Groundwater Transfer Review Summary Form

Transfer/PA # T- 14744

Application: T-14744

Applicant Name: Tate & Kimberly Koenig

Application T14744
T4S/R1W-S02

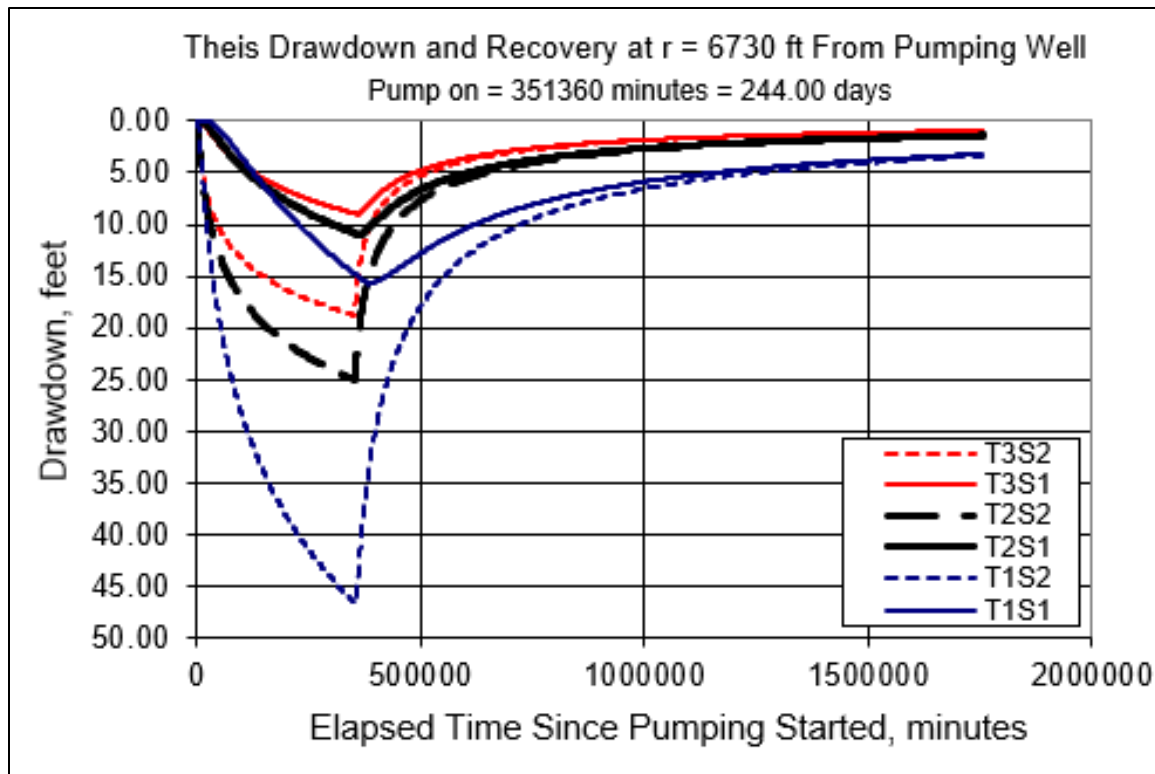
5. a) Will this proposed change, at its maximum allowed rate of use, likely result in an increase in interference with **another ground water right**?
☒ Yes ☐ No Comments: The proposed POA is moving closer to a quite a few wells completed in the Willamette Aquifer near French Prairie, most of which do not fully penetrate the Willamette Aquifer. However, there are some wells closer to the Willamette River that are completed in the underlying Columbia River Basalts. The nearest of these CRB wells is CLAC 8638. The outer string of casing is set in a gravel layer of the Willamette Aquifer and it seems that the inner string of casing may be set in sedimentary units above the first mention of basalt in the well log at 806 ft. The well is sealed down to 30 ft BLS with local clay and possibly commingles the basalt and alluvial aquifers.

- b) If yes, would this proposed change, at its maximum allowed rate of use, likely result in another groundwater right not receiving the water to which it is legally entitled?
☐ Yes ☒ No If yes, explain: While interference with nearby wells would likely increase with neighboring wells at maximum allowed rate of use, only wells that fully penetrate the Willamette Aquifer can claim injury due to the proposed changes of this application due to OAR 690-008-0001(8)(c). A drawdown analysis for CLAC 8638 (attached) was conducted for pumping at max rate at the proposed POA compared to max rate at the authorized POA. Using the most conservative aquifer parameters, the simulated increase in drawdown was 2.89 ft from 43.68 ft to 46.57 ft. Given the relatively small increase in drawdown at max rate, injury would be unlikely to occur given the total depth of the affected well. Additionally, the estimated rate of use at the proposed POA is 0.03 CFS. This smaller rate of use would further minimize the risk of interference with neighboring wells that fully and partially penetrate the aquifer.
